**FINAL ALTERNATIVES ASSESSMENT  
OF  
INTERIM RESPONSE ACTIONS  
FOR  
OTHER CONTAMINATION SOURCES  
MOTOR POOL AREA  
NOVEMBER 1989  
CONTRACT NO. DAAA15-88-D-0022/0002  
VERSION 3.1**

**WOODWARD-CLYDE CONSULTANTS**

**U.S. ARMY PROGRAM MANAGER'S OFFICE  
FOR ROCKY MOUNTAIN ARSENAL CONTAMINATION CLEANUP**

Figure 1-1 MOTOR POOL AREA  
VICINITY MAP

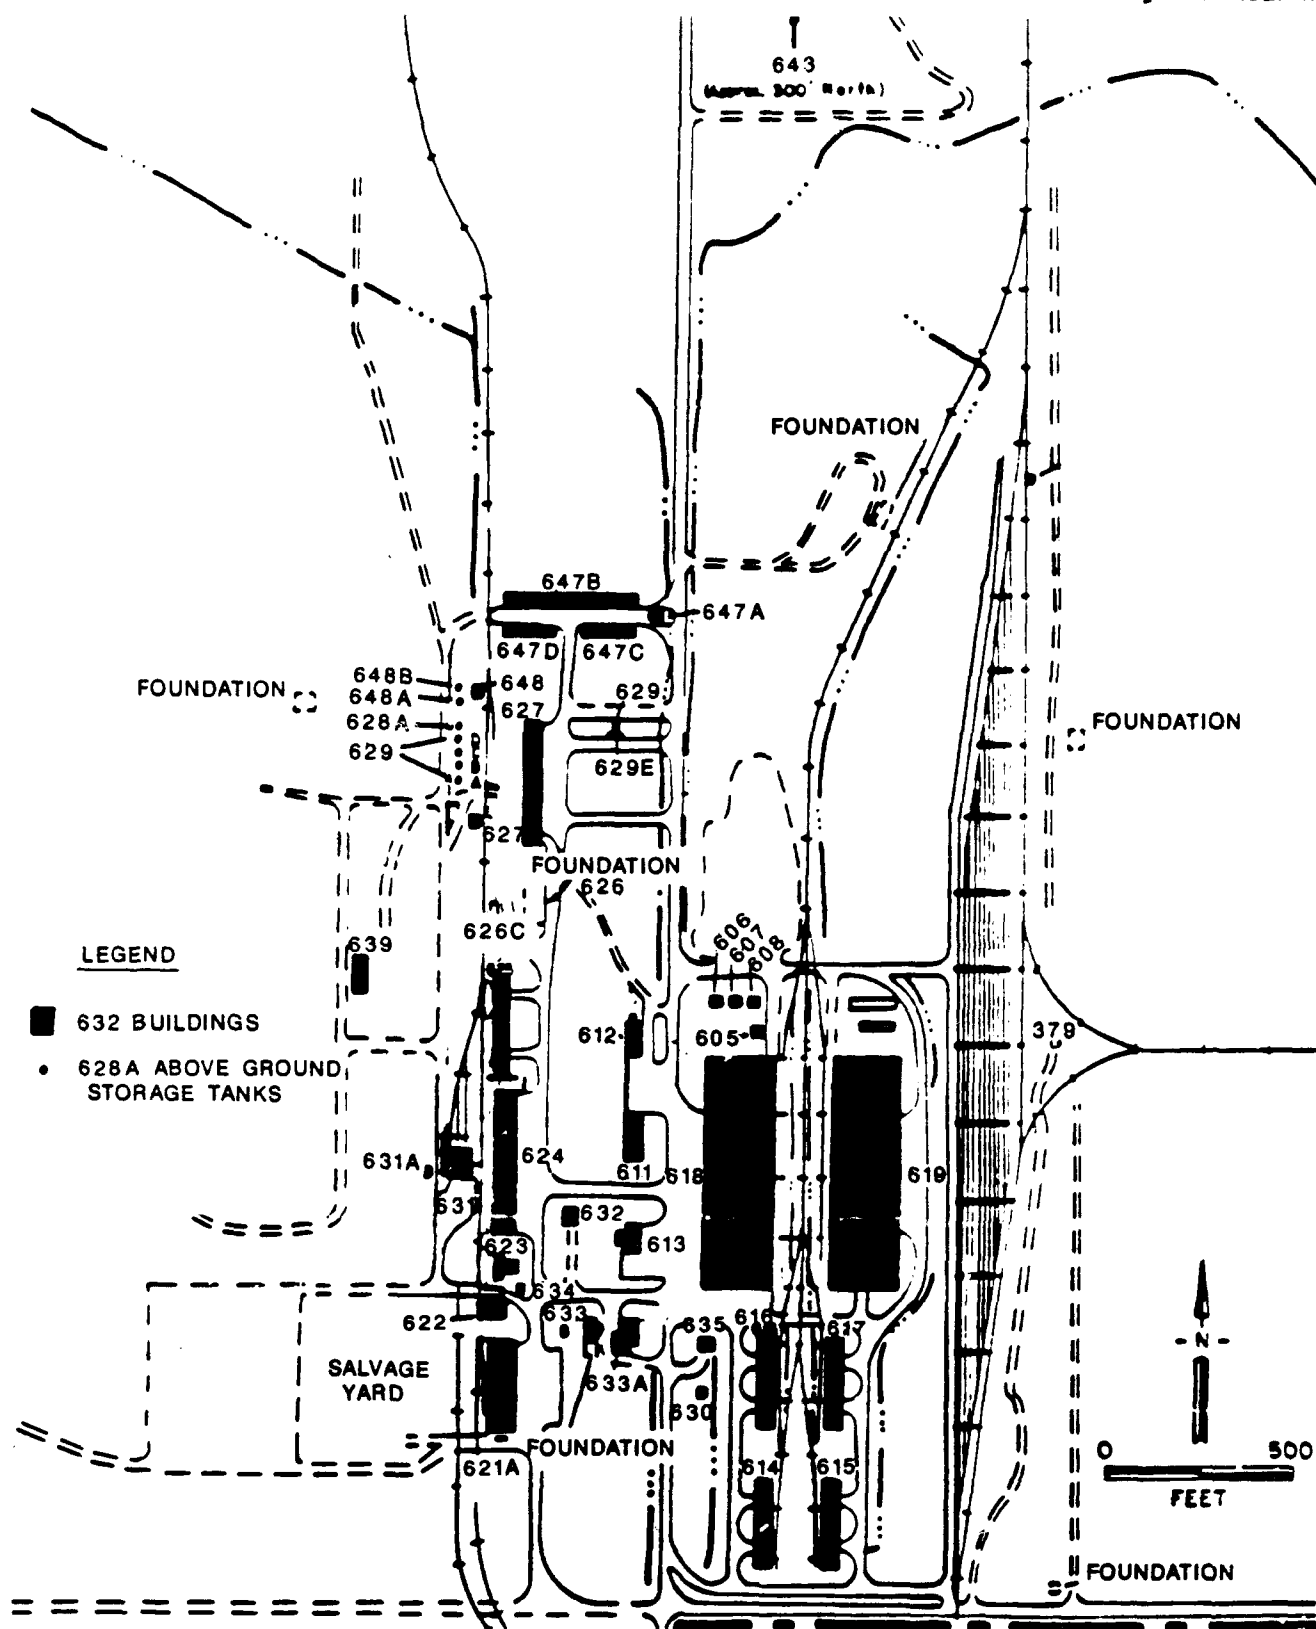
Comment 2: Figure 1-1 - The legend for this figure is not clear and should therefore be corrected.

**Figure 1-2 - DECISION FLOW CHART FOR  
INTERIM ACTION VERSUS  
MONITORING/MAINTENANCE  
ON HOT SPOT IRAs**

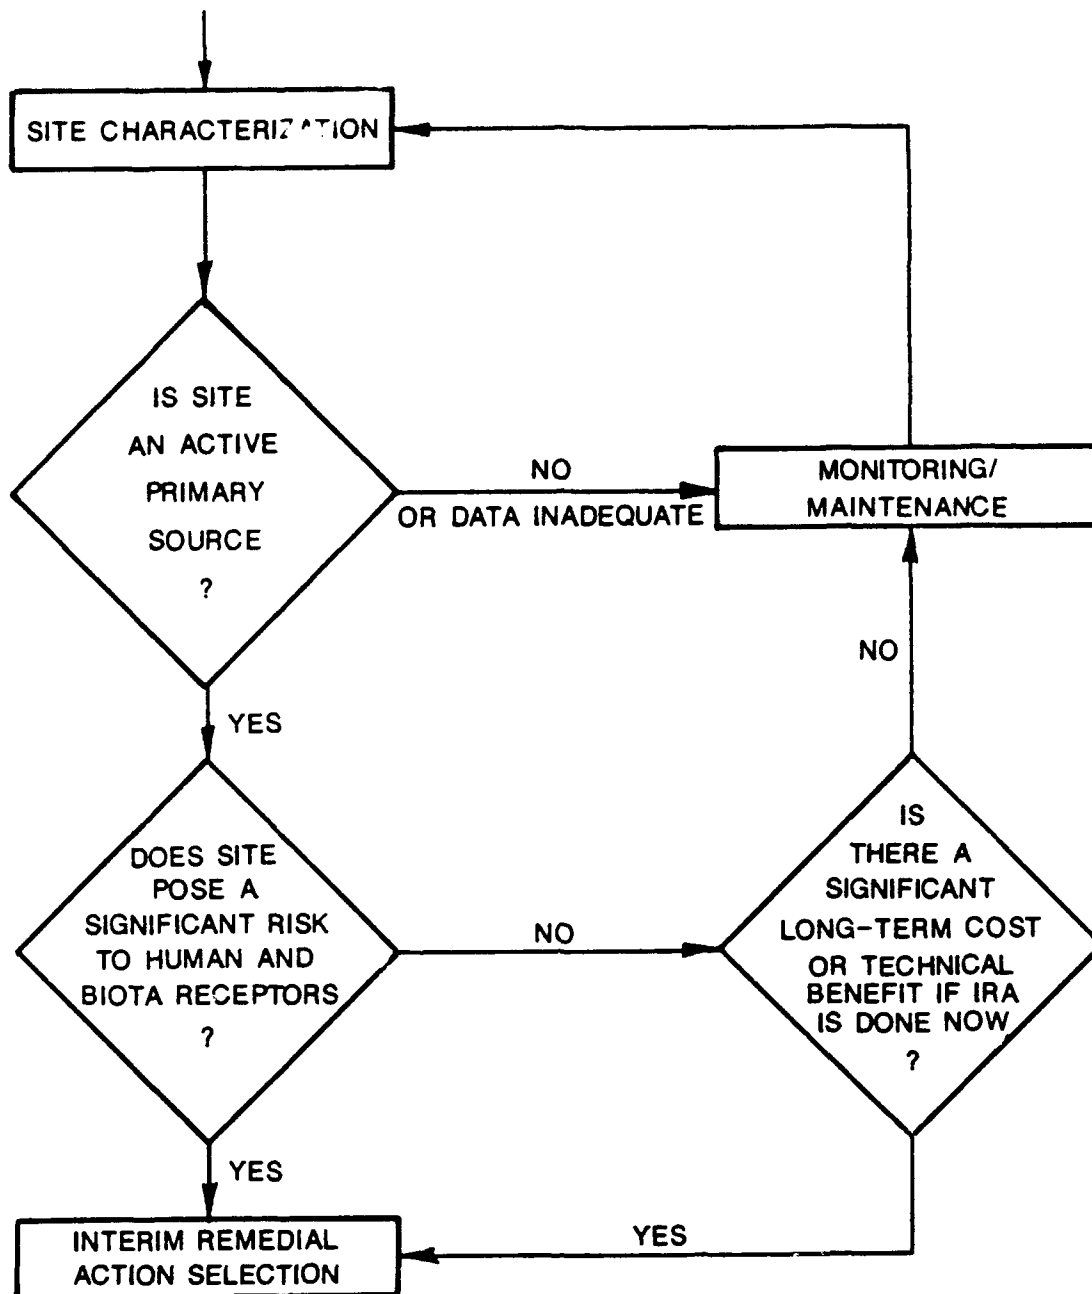
Comment 3: Page 1-3 & 1-4 - The candidate selection criteria discussed on pages 1-3 and 1-4 do not accord with the flow chart presented as Figure 1-2. Specifically, the flow chart's initial diamond which presents the threshold question of whether the site is an active, primary source of contamination does not limit that question to an assessment of the site's effect on ground water. Such a limitation was expressly disapproved by State representatives at the June 7, 1989 subcommittee meeting which was held to discuss screening criteria for the "other sources" IRA.

Comment 3: The Decision Flow Chart presented in this assessment (Figure 1-2) is an altered version of the Flow Chart actually agreed to by the Organizations and the State at the June 7, 1989 Other Contamination Sources Subcommittee meeting. Specifically, Data Inadequate should be on the NO leg of the first decision node, not on the YES node. The version agreed to is shown in Figure 1-1 of the final Technical Plan.

**Figure 2-1 WATER TABLE ELEVATIONS,  
GENERALIZED GROUND WATER FLOW  
DIRECTION, AND WELL LOCATIONS**

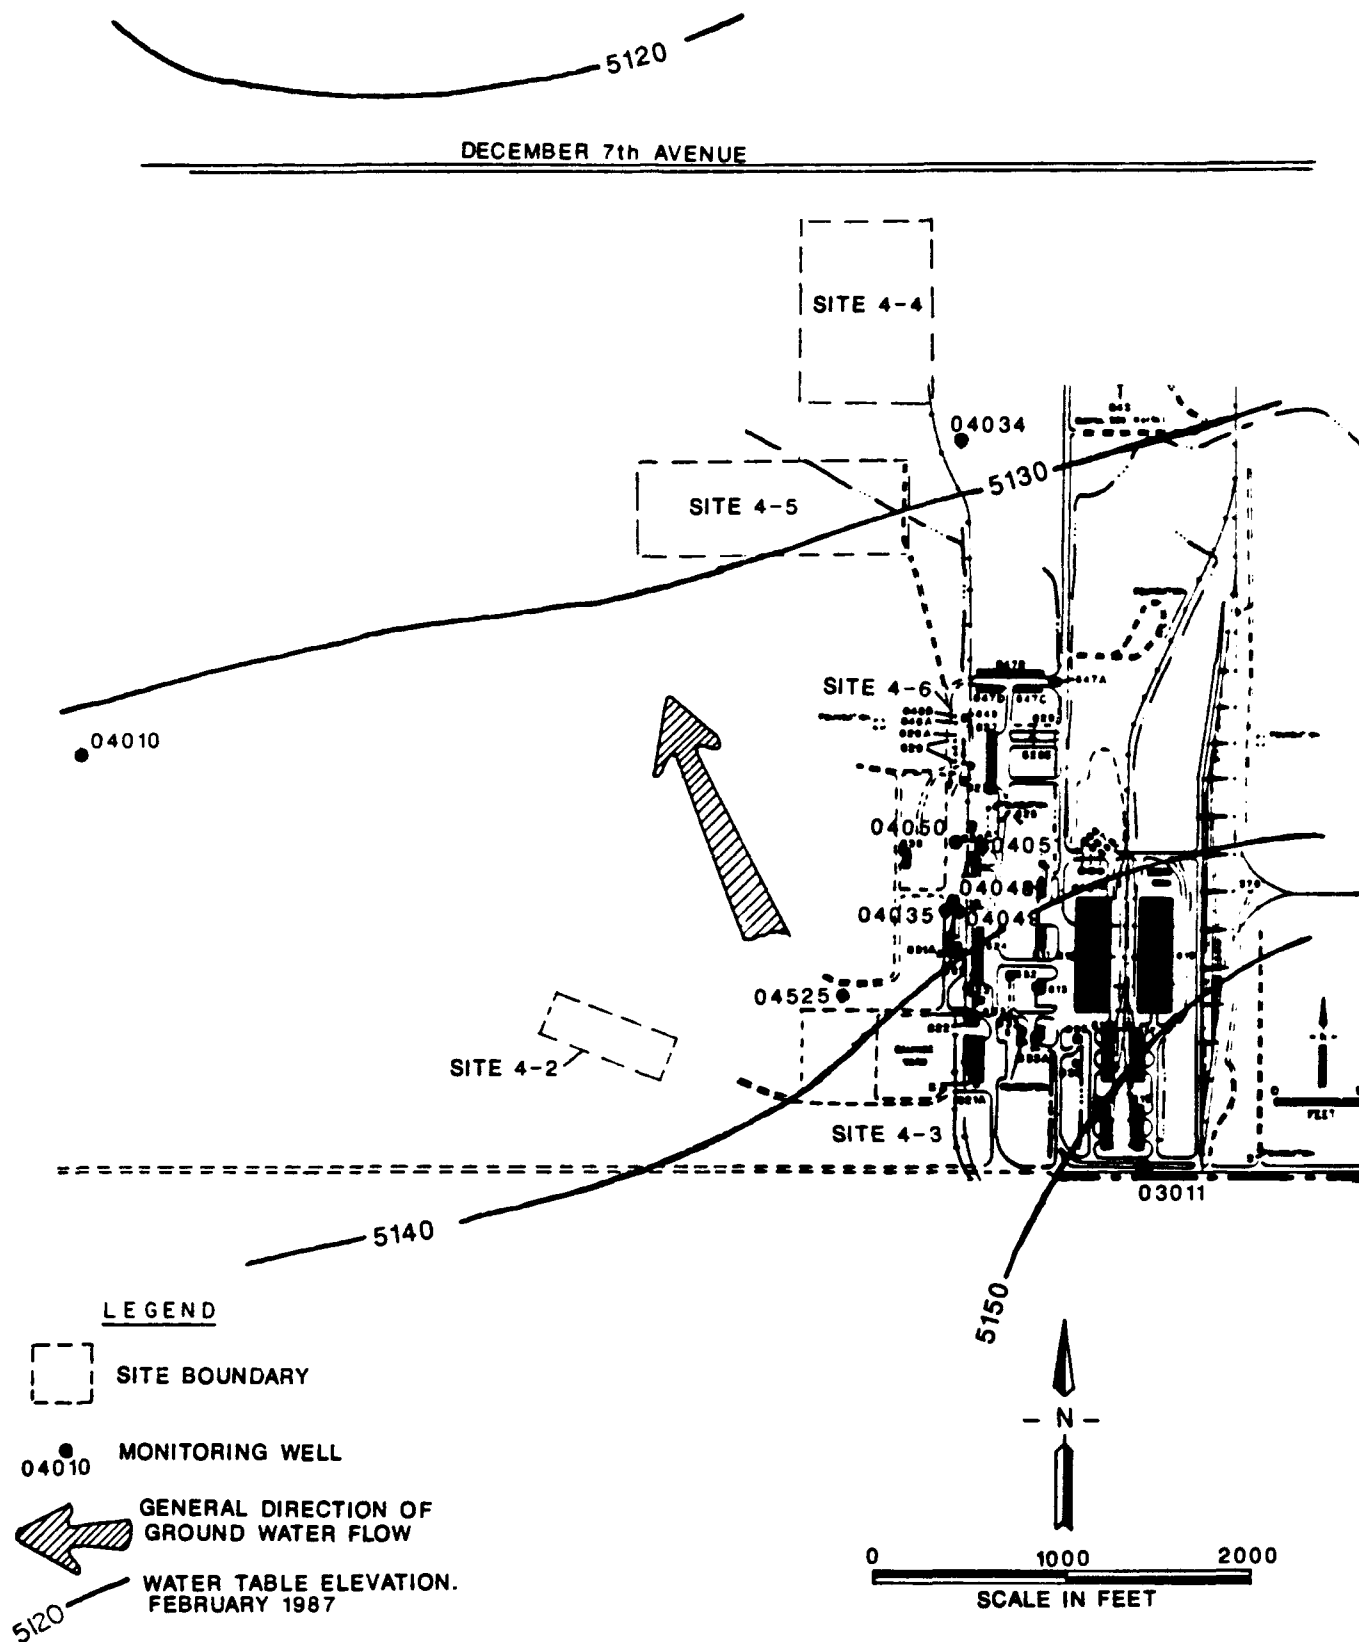
Should the reference (Table 2-2) be (Figure 2-1) instead? Table 2-2 does not identify water quality by wells, but Figure 2-1 shows well locations but no water quality data. It would be helpful if a TCE plume map were provided in this Section.

**FIGURE 2-2 TCE SOIL GAS  
SURVEY MOTOR POOL AREA**

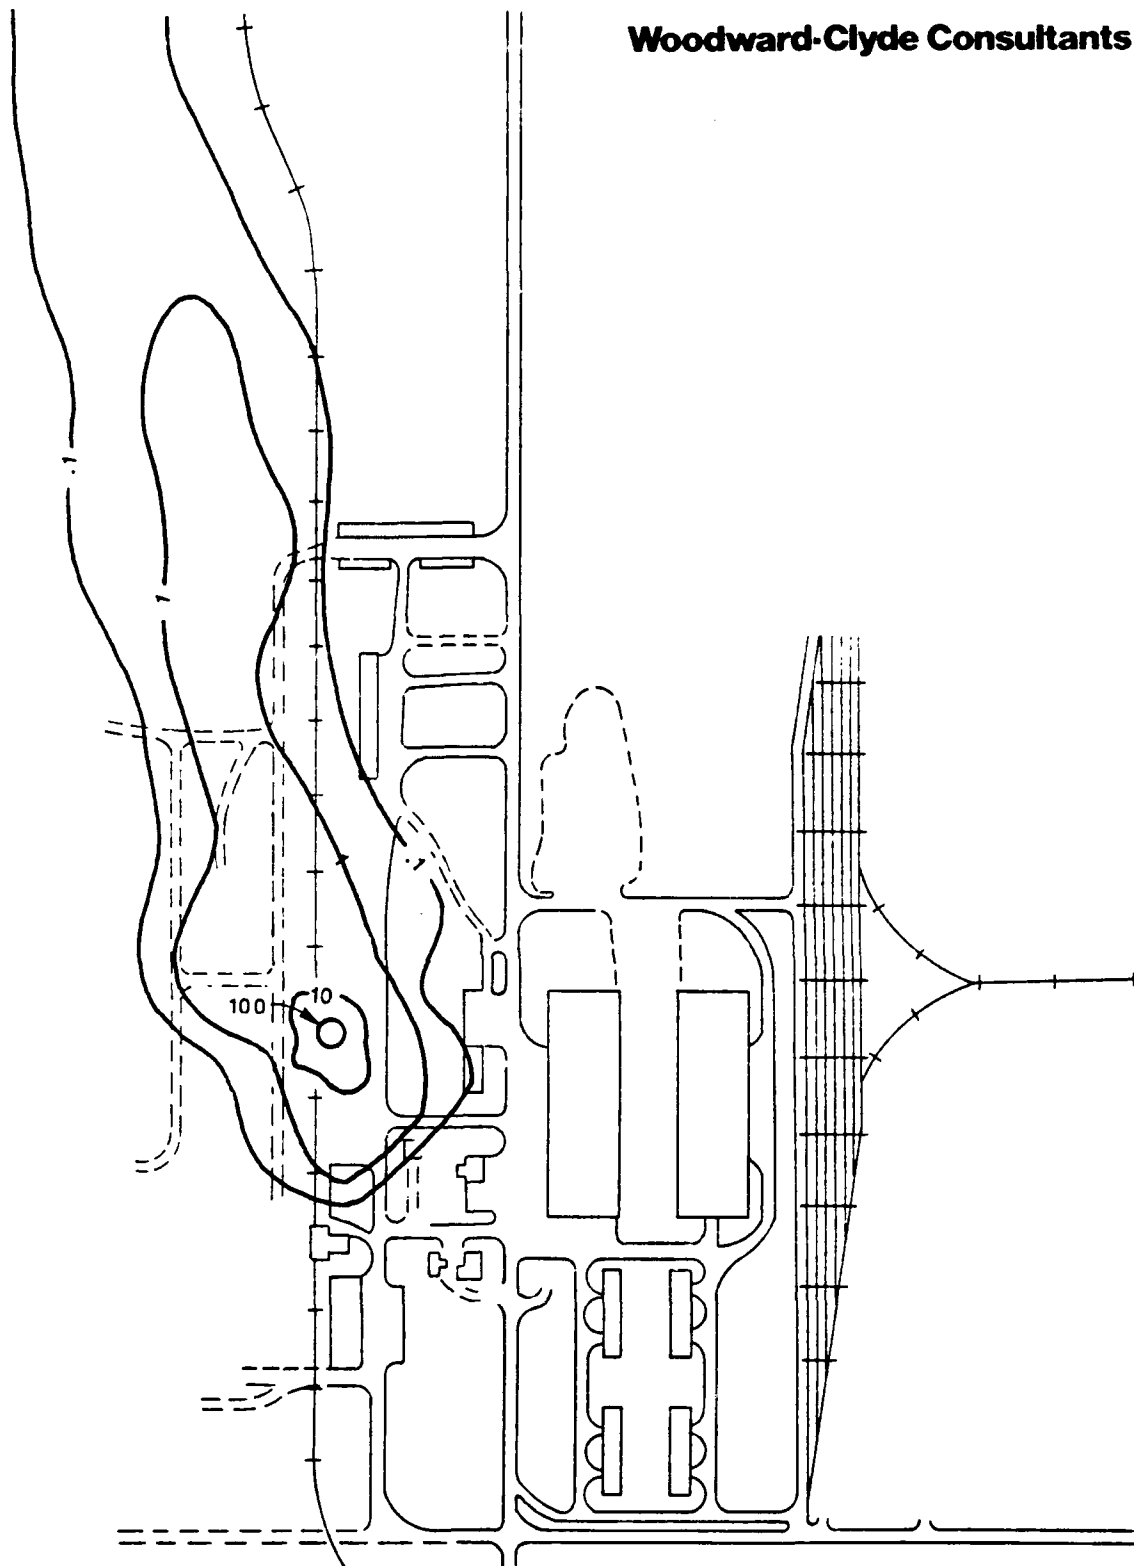
The standard soil gas sampling depth is stated as 15 feet in the text but appears to be 5 feet on Figure 2-2. Which is correct? Figure 2-2 is very difficult to read and the locations of the buildings should be made clear. Also, soil gas concentrations are not shown for many of the 5-foot sample locations.

No data are presented to substantiate this statement. Maximum sampling depth in the 1989 soil gas sampling program was described as 15 feet, although Figure 2-2 shows one sample point at 20 feet at location G5. No significant attenuation of the TCE concentration occurred at this depth.

Response: Figure 2-2 has been revised to provide a better summary of results for the purposes of this document. The standard sampling depth was 15 feet -- the figure was incorrect. Details of the investigation and results can be found in the Field and Laboratory Investigation Report (WCC 1989).
